GENERAL INFORMATION

Location: 8200 Humboldt Avenue South

3. Preliminary and final development plans for a four-

story, 149-unit apartment building.

Figure 1: Existing and Proposed Land Use Designation

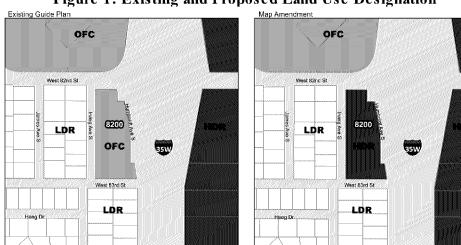
The current Office land use designation allows for residential uses, but only if integrated with a non-residential use permitted in the underlying zoning district. The proposed development is entirely residential, so inconsistent with the Office designation. The High-Density Residential land use designation, the proposed land use designation, would be consistent with the residential only development. Figure 1 depicts the current and proposed land use designation. The Metropolitan Council is the final review authority for Comprehensive Plan Amendments.

Figure 2: Existing and Proposed Zoning Designation

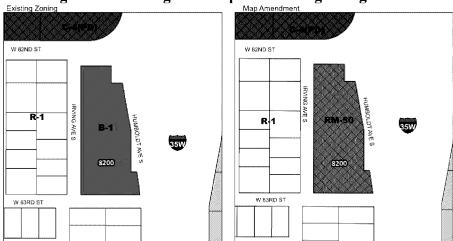
Figure 2 depicts the existing and proposed zoning designation. The B-1 zoning district does not allow residential uses, so the property must be rezoned to accommodate the proposed

Provided the City Council approves the Comprehensive Plan Amendment from General Business to High-Density Residential, the proposed RM-50 zone would be the most consistent zoning district for the proposed development. In total, the development would entail 46 units/acre, which is within the 20 to 50 dwelling unit density range for the RM-50 zoning district.
